## **Board of County Commissioners Summary Report**

**Case name:** **PM22-006**  
**Arcadia Creek**

RE: Arcadia Creek – Variance Requests to the Private Access

Re: Revised Variance Request Arcadia Creek  
Technical Review Committee

PRELIMINARY LAYOUT PLAN

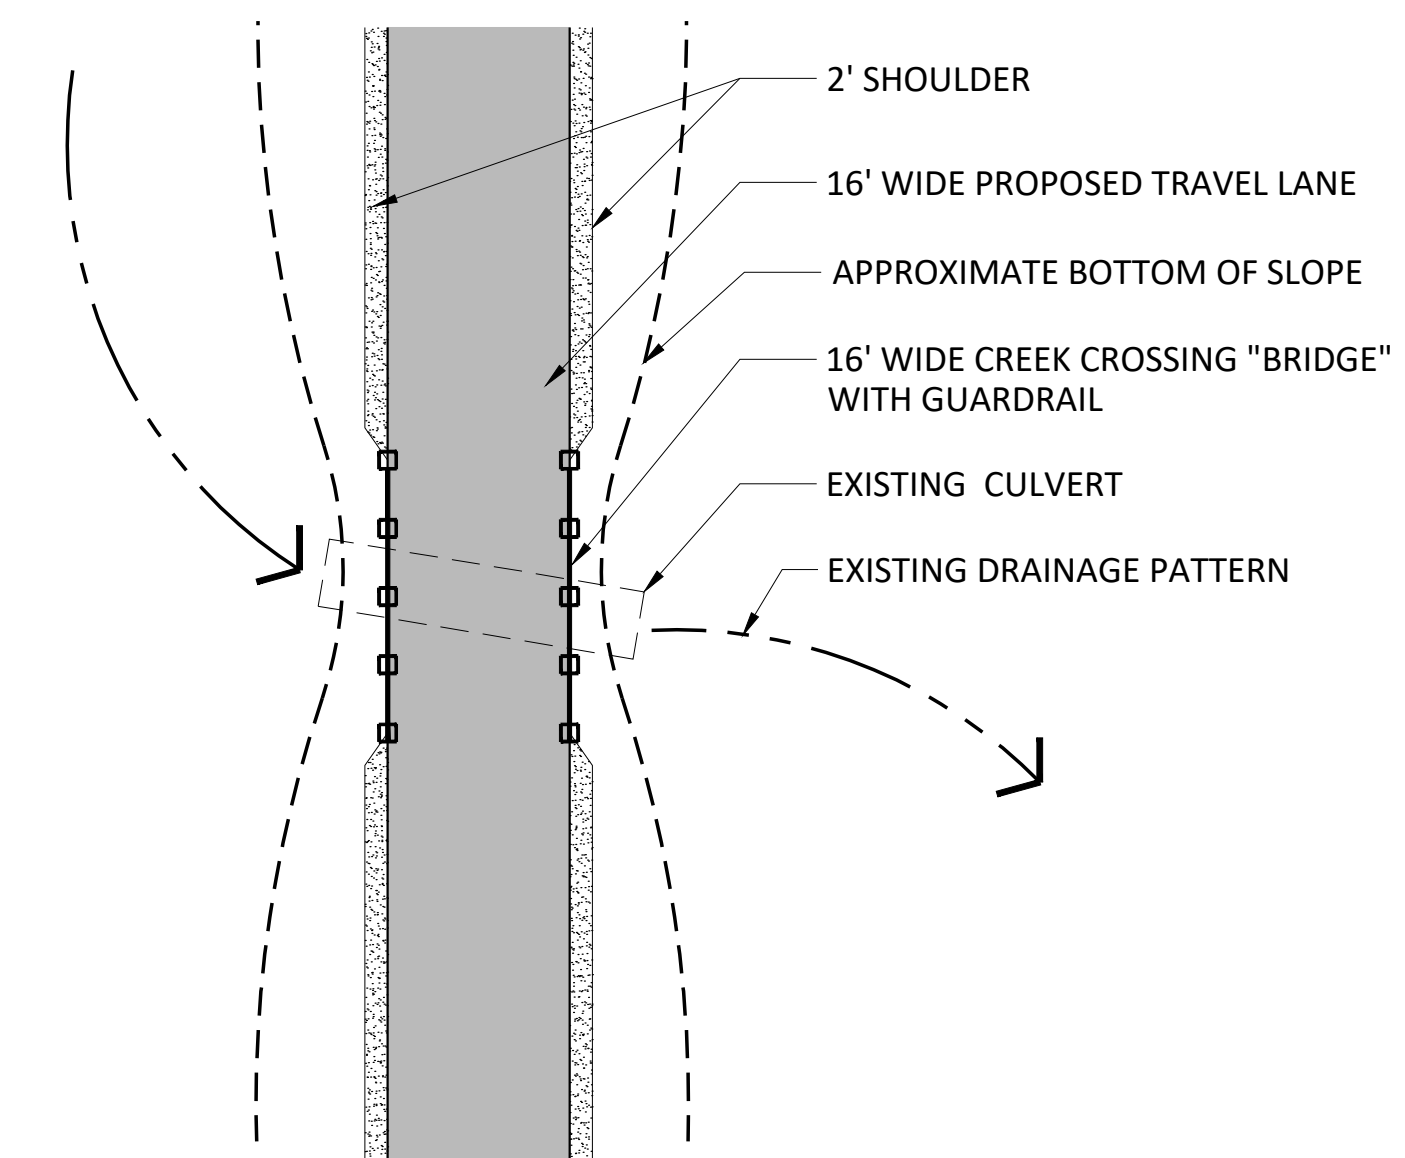
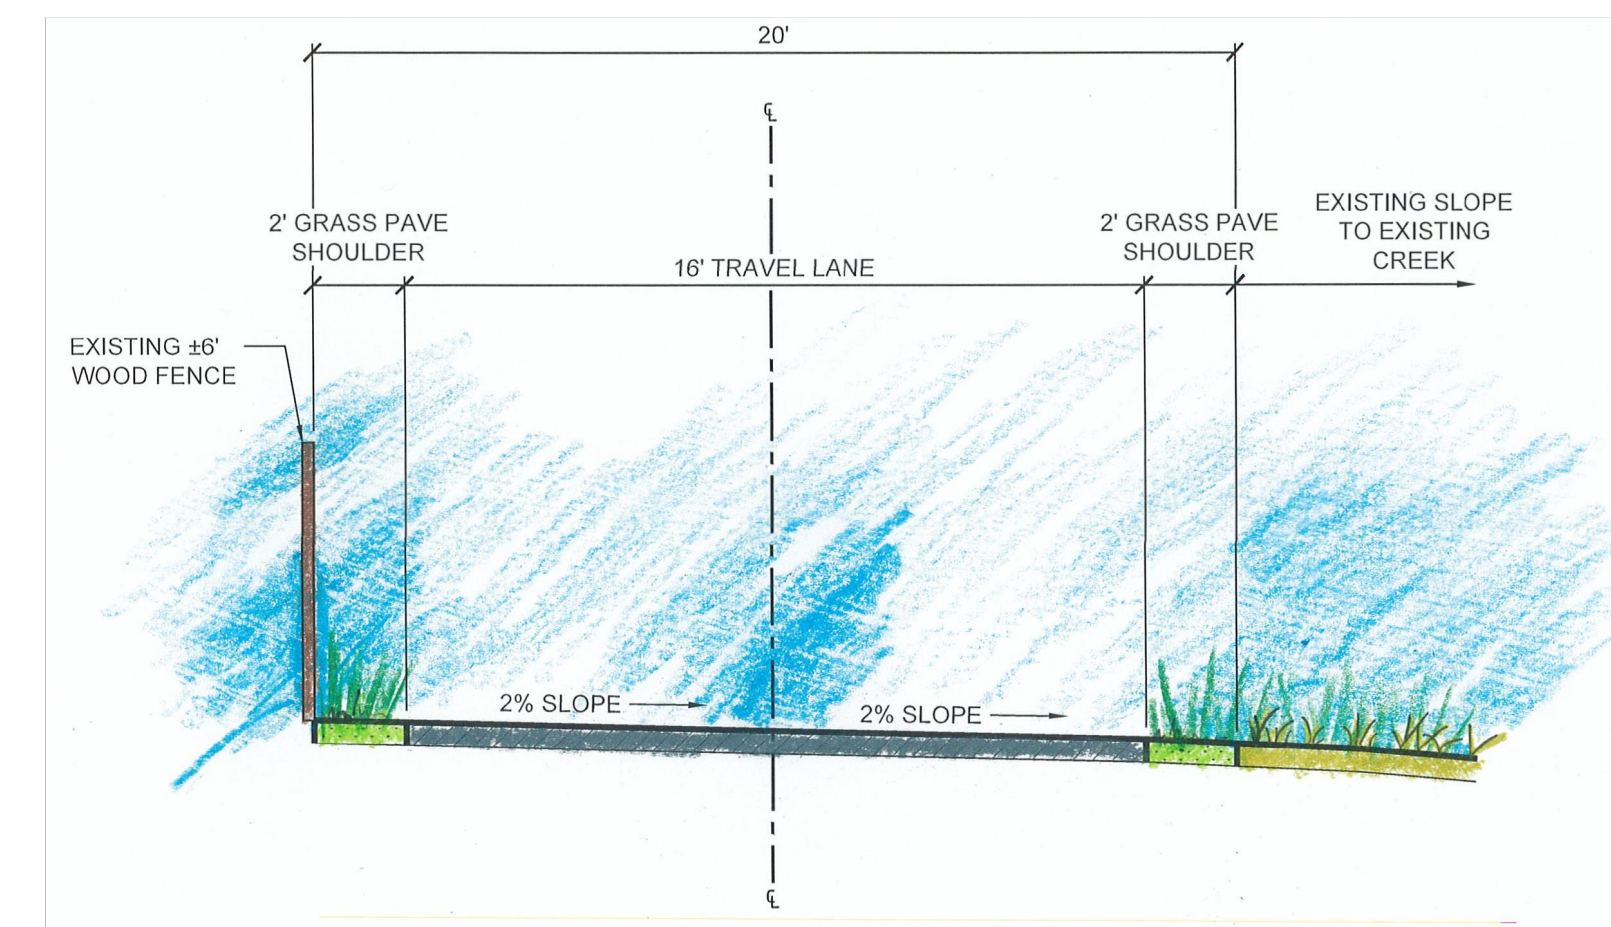
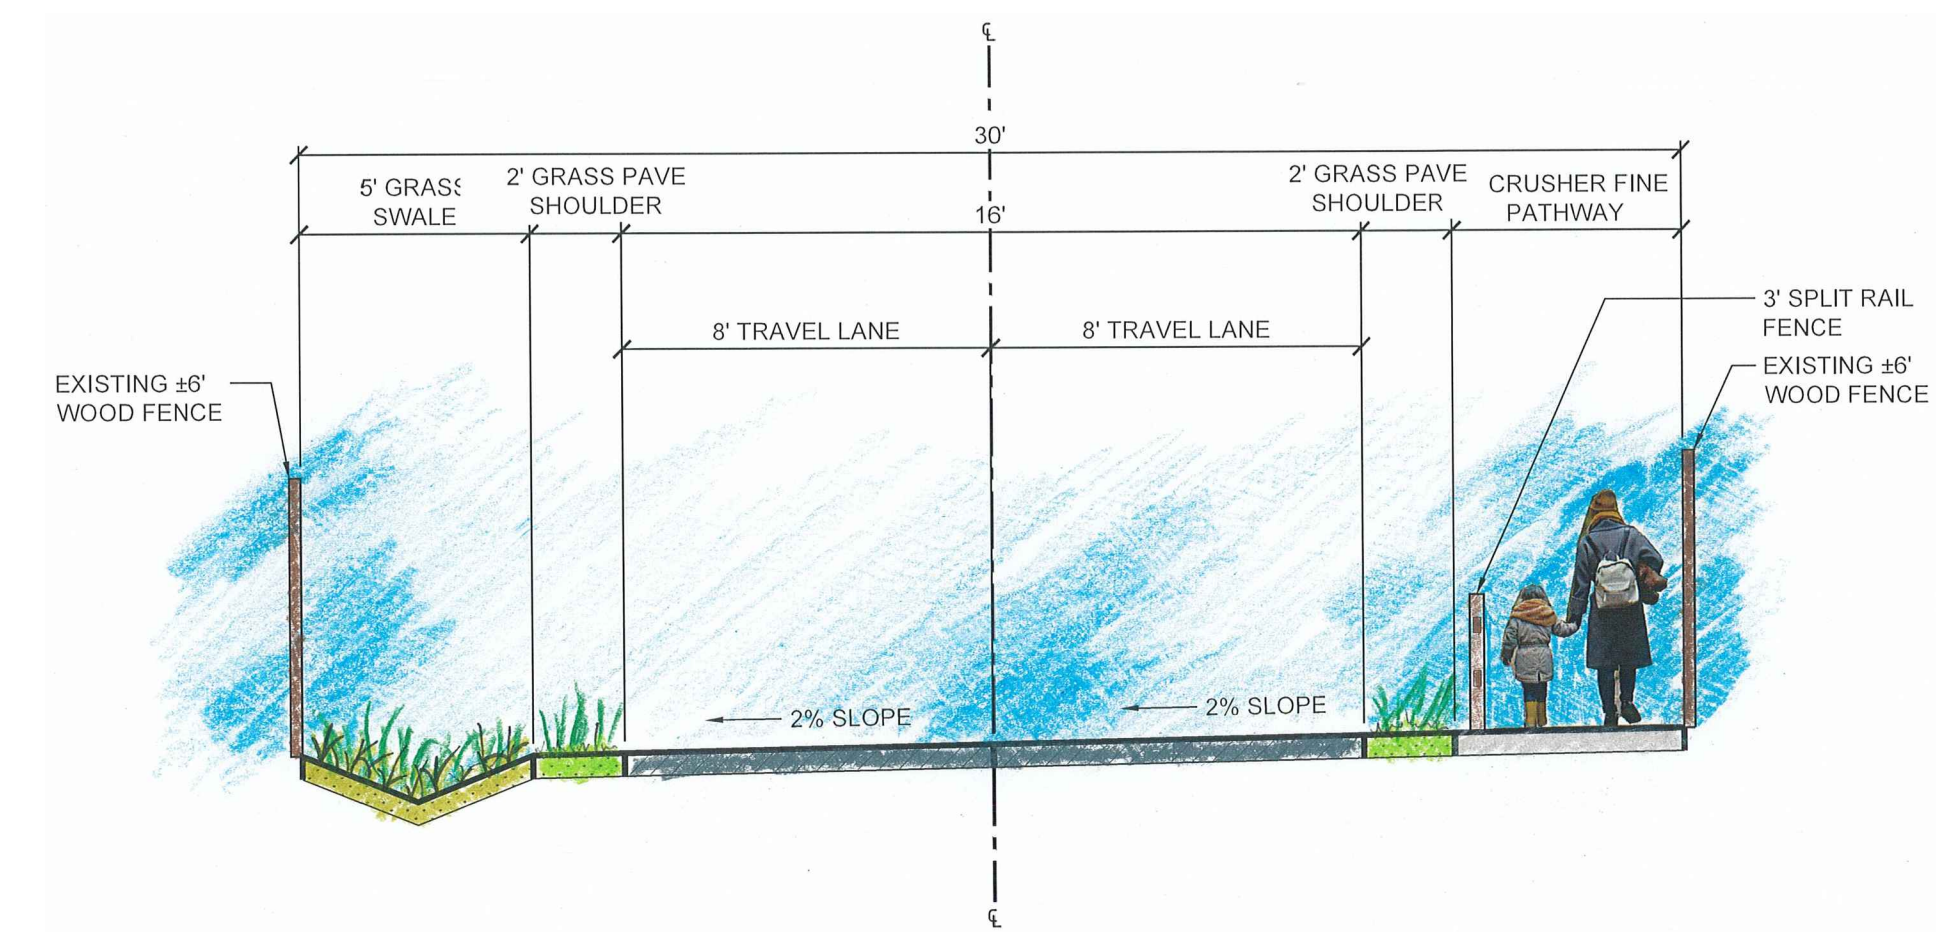
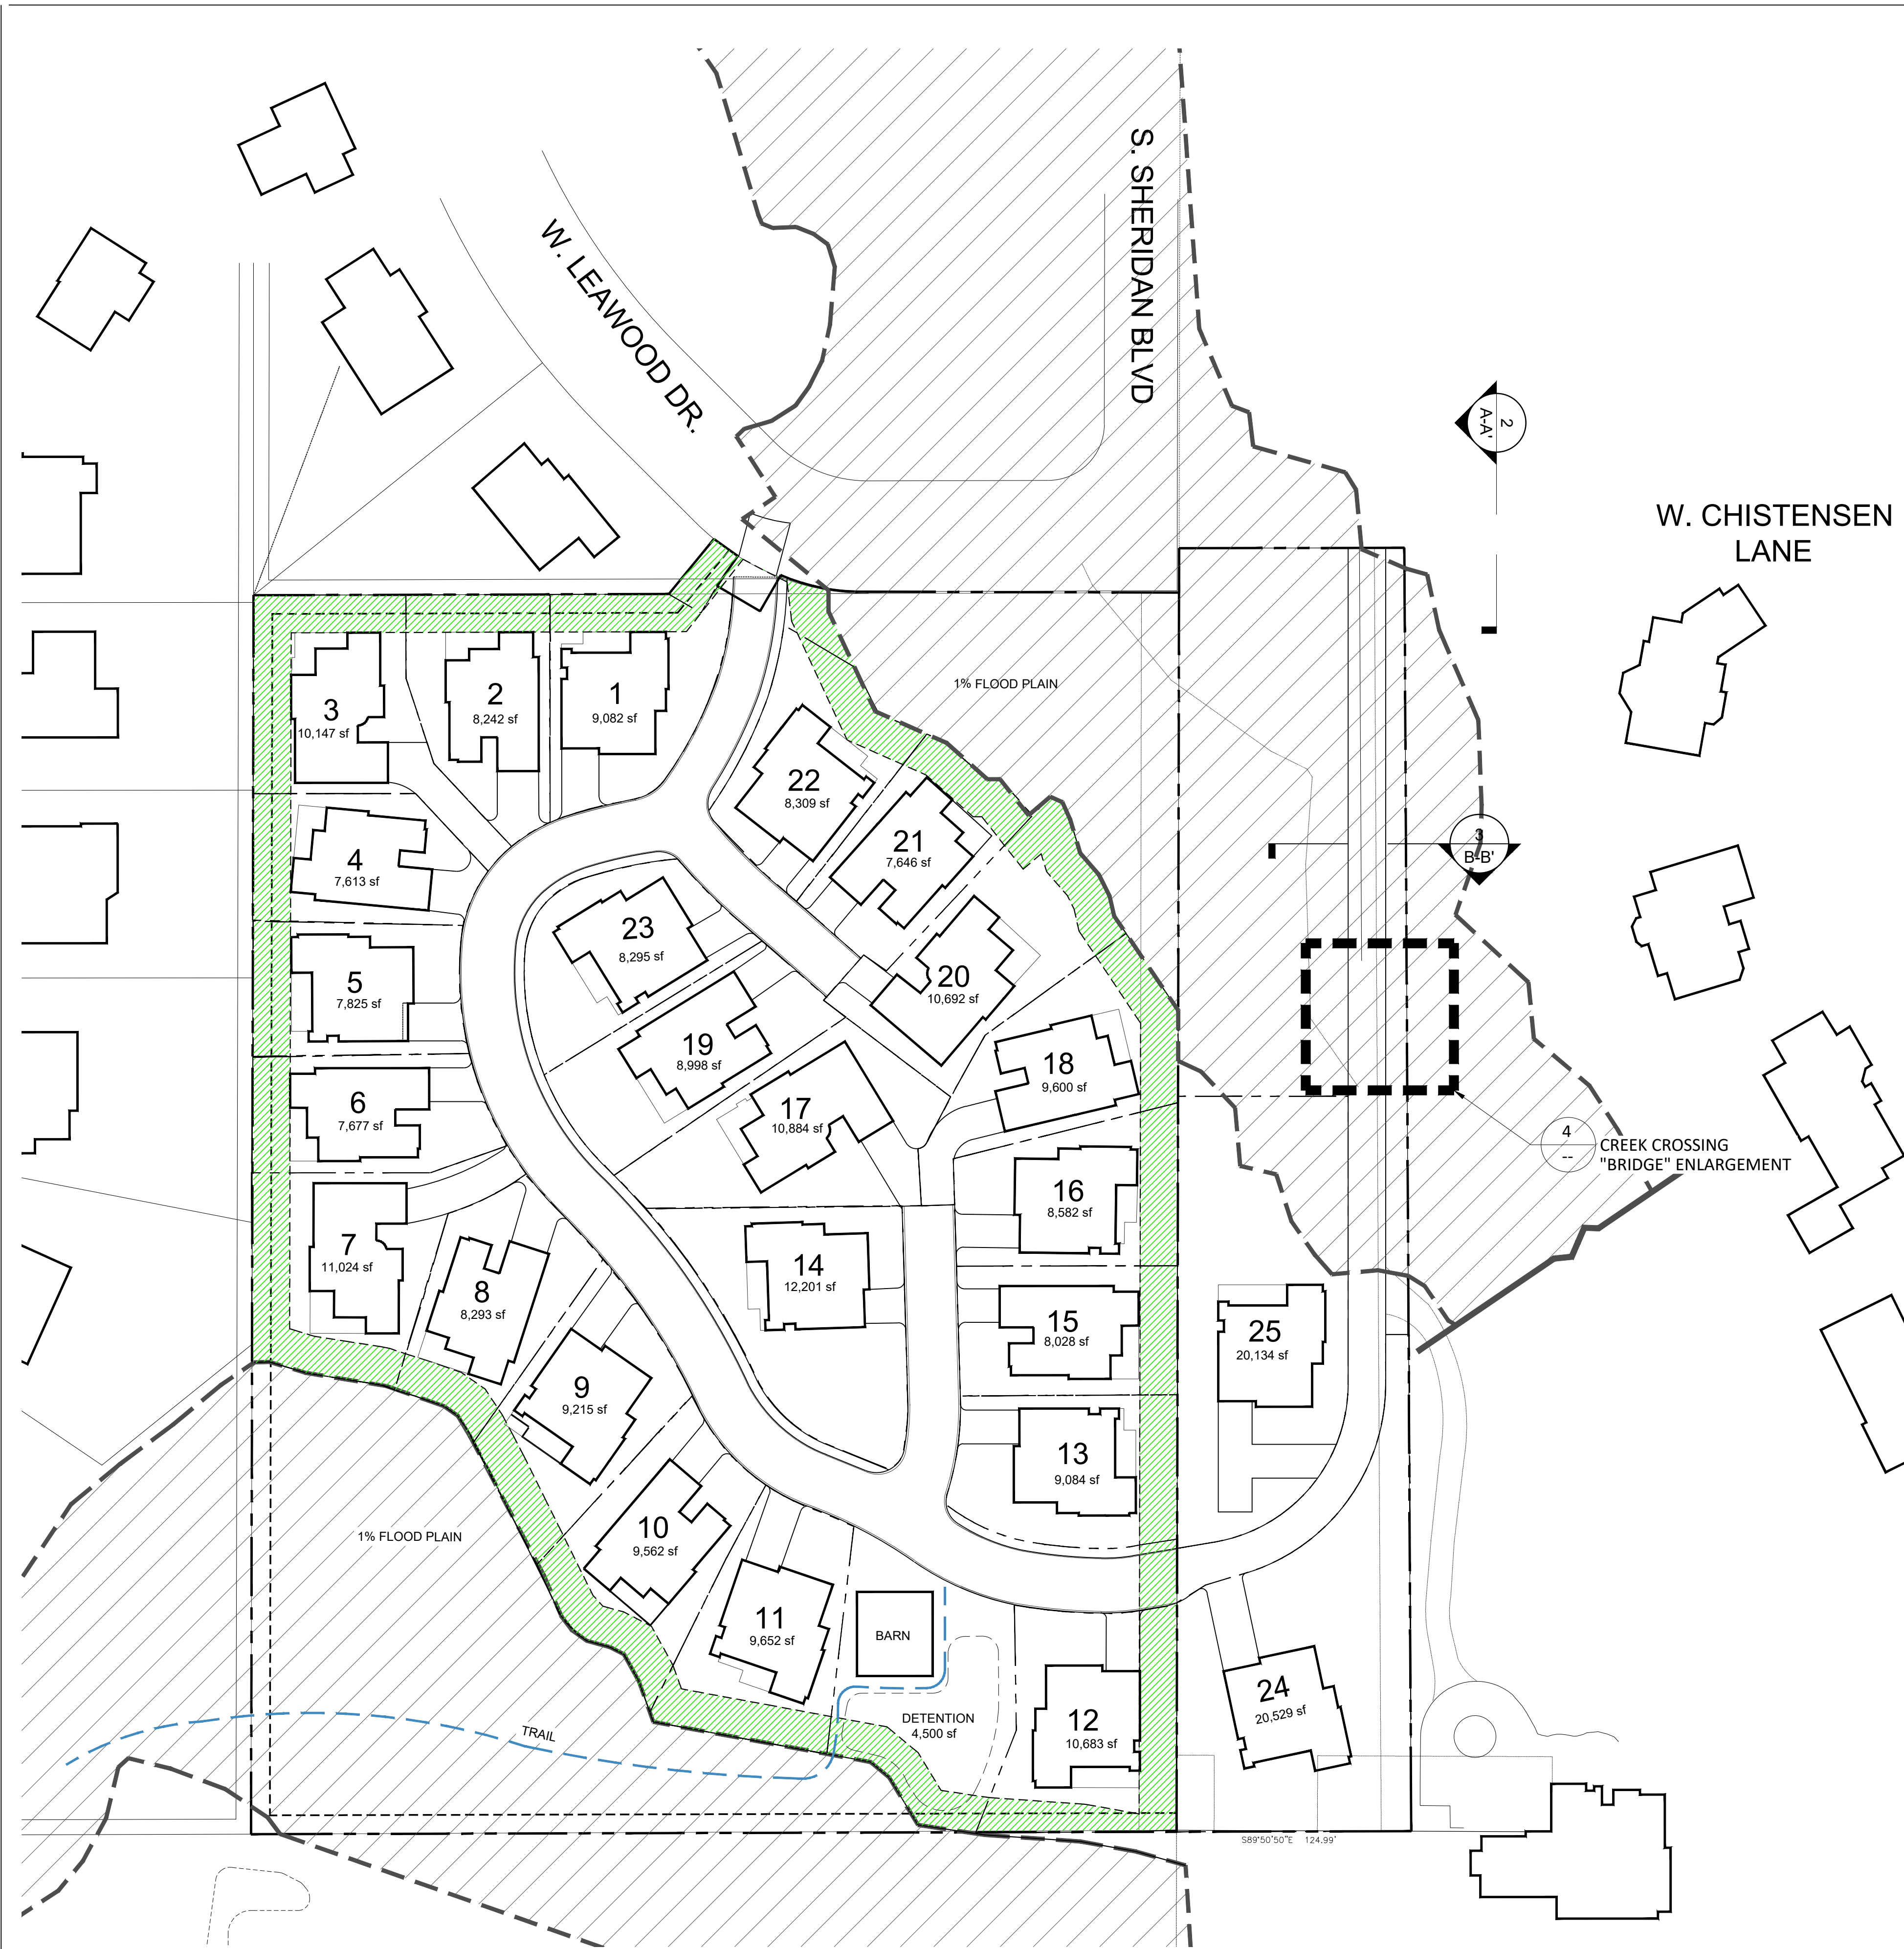
The followings are the TRC's recommendations for the private access:

- The proposed cross section of the private access and the gate use plan must be reviewed by the Fire District, and the Fire District's approval is required.

- Recommends "No Parking" signs along both sections of W. Christiansen Lane be installed. This should also be determined and approved by the Fire District.

- Clarify the intention of the pedestrian path – whether the path is open to the public or private.
- Public Use Easement is required through the pedestrian path section.

- W. Christensen Lane is connecting directly to a State Highway. Arapahoe County will contact CDOT for the usage of the State Highway by the additional traffic generated from the Development.

- The stream crossing at the private access/Coon Creek should be updated if this private access is being upgraded pursuant to the Phase B Preliminary Design Report for Dutch Creek, Coon Creek, Lilley Gulch and Three Lakes Tributary. The Mile High Flood District (MHFD) makes the recommendation to the design of this stream crossing.

- No fence should be allowed within the floodplain. Arapahoe County's Floodplain Regulation prohibits the fence be placed within the 100-year floodplain.

- Concerns about the emergency access during a flood event. The Developer needs to verify if there is an access to a public road without going through a floodplain including the access in Jefferson County.
